Whipple Consulting Engineers, Inc.

October 30, 2023
WCE No. 2021-3109

**Re: Response to Determination of Incompleteness
Beard Addition – A Residential Subdivision and PUD**

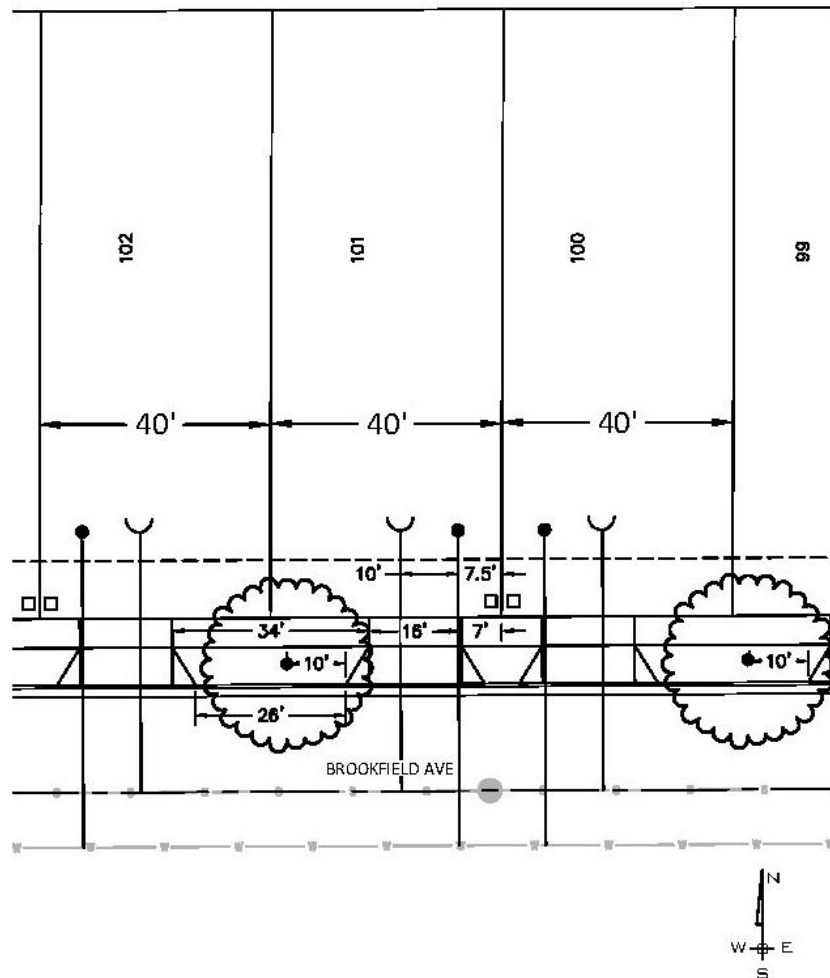
- b. *Street trees are required. Compliance will be verified at time of certificate of occupancy for each new home consistent with the development’s approved landscape plan.*

WCE Response: This comment is noted; however, it should be noted that a 40’ lot with utilities can only support one tree on every other lot. Below is a diagram identifying the location of utilities, driveways and the street trees.
